Office Action Summary	Application No. 10/773,500	Applicant(s) CURRY ET AL.	
	Examiner Benjamin P. Lee	Art Unit 3641

DETAILED ACTION

3. Claims 10 and 21 are rejected under 35 U.S.C. 102(b) as being anticipated by Leffel et al. (U.S. Patent 4691614).

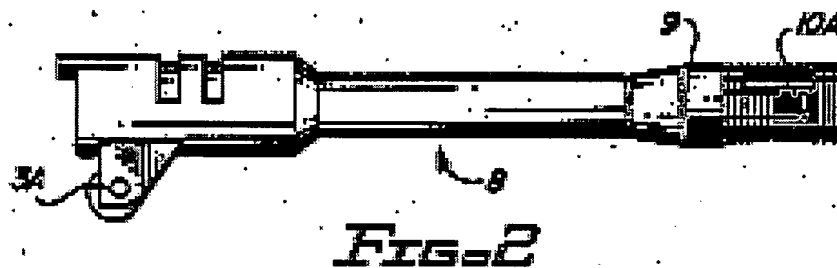
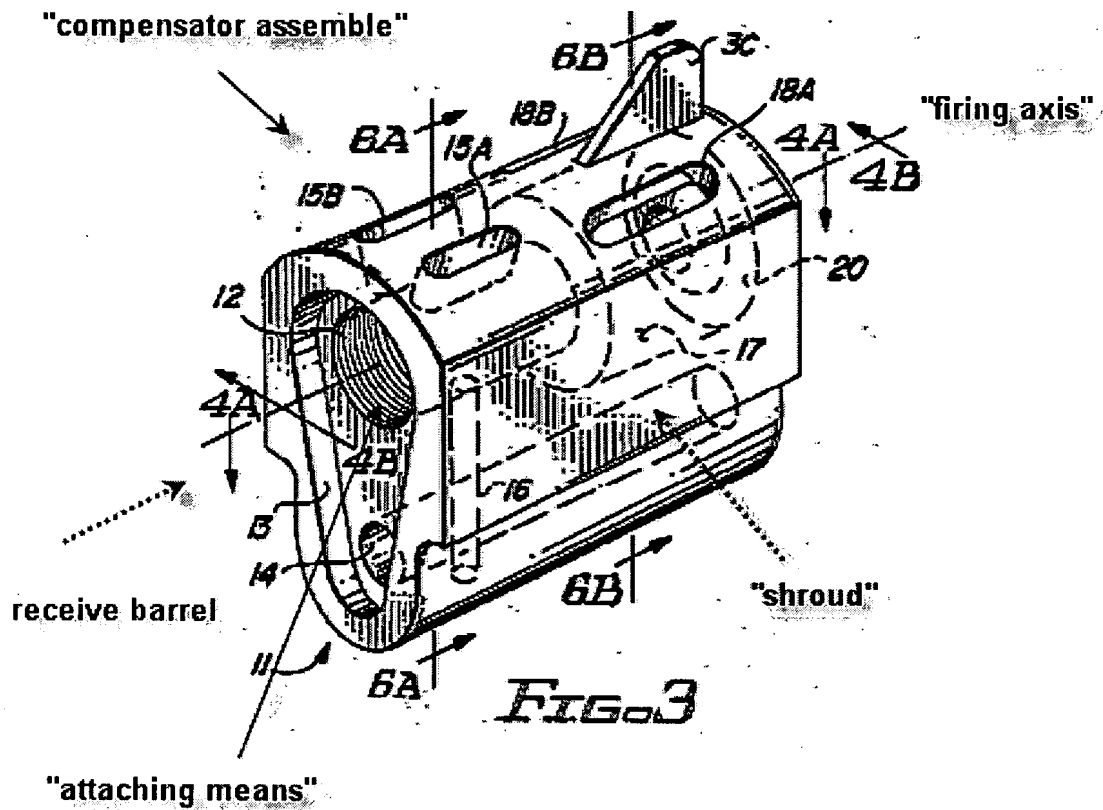
4. Claims 1 and 5 are rejected under 35 U.S.C. 102(b) as being anticipated by Kleinguenther et al. (U.S. Patent 5305677).
5. In regards to claim 1, Kleinguenther et al disclose the following:
 - a. a barrel having a longitudinal bore and defining thereby a firing axis (item 1 of fig. 2 following);
 - b. a compensator assembly including an attaching means for releasably

- c. a gas discharge port formed only in an upper three quarters of said compensator assembly (items 9 of fig. 2 following). Note that Kleinguenther et al does disclose a compensator assembly with a discharge port this is "formed only in an upper three quarters of the compensator". Applicant is advised that this language merely claims that a port must be formed only in the upper three quarters and not have any portion of "the port" in another part of the compensator;
- d. gas discharge port not being aligned with said longitudinal bore and communicating with an inner bore of said compensator assembly (see fig. 2 following). Note that the compensator walls define an inner bore and the exhaust ports are "communicating" with this inner bore.

2. In regards to claim 5, Kleinguenther et al disclose that the barrel includes a recess formed therein and said attachment means is configured to be releasably accepted within said recess (item 10 of fig. 2 following and col. 3, lines 18-20). Note that the threaded section constitutes a "recess" and the compensator attachment means

is configured to be releasably accepted (screwed) within the recess in the barrel.

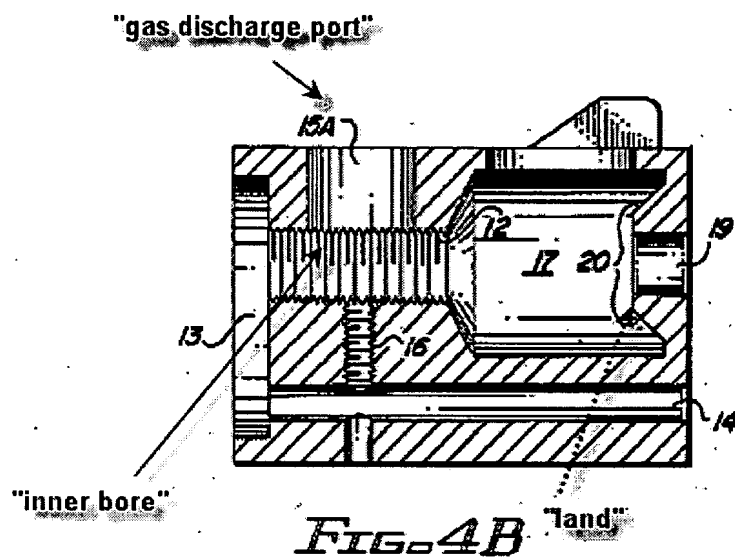
- a. a barrel having a longitudinal bore and defining thereby a firing axis (item 8 of Leffel et al fig. 2 following);
- b. a compensator assembly including an attaching means for releasably attaching said compensator assembly adjacent a muzzle end of said barrel (see Leffel et al figs. 2, 3 and 4B following);

- c. a gas discharge port (items 15A or 15B of Leffel et al fig. 3 following) formed in said compensator assembly, said gas discharge port not being aligned with said longitudinal bore and communicating with an inner bore of said compensator assembly (see Leffel et al fig. 4B following);

- d. said barrel includes a gas aperture (item 10A of Leffel et al fig. 2 following) which is aligned with said gas discharge port when said compensator assembly is attached adjacent said muzzle end of said barrel;

- e. said gas aperture not being aligned with said longitudinal bore (see Leffel et al figs. 2 and 3 following).

Leffel, et al.

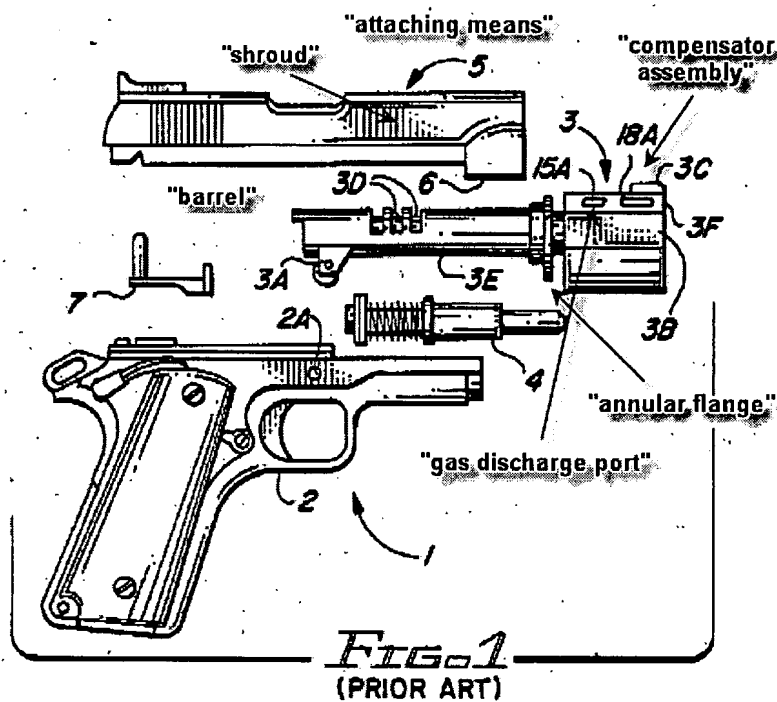
- a. a shroud having a longitudinal bore (item 5 of Leffel et al fig. 1 following);
- b. a barrel releasably housed within said shroud and defining thereby a firing axis (see Leffel et al fig. 1 following), said barrel including an annular flange disposed on a distal end of said barrel for arresting a longitudinal translation of said barrel within said longitudinal bore, said annular flange having a flange diameter which is greater than an outer diameter of said barrel (see Leffel et al fig. 1 following);

- c. a compensator assembly including an attaching means for releasably attaching said compensator assembly adjacent a muzzle end of said barrel (see Leffel et al fig. 1 following);

- d. a gas discharge port (item 15A of Leffel et al fig. 1 following) formed in said compensator assembly, said gas discharge port not being aligned with said longitudinal bore and communicating with an inner bore of said compensator assembly (see Leffel et al fig. 1 following).
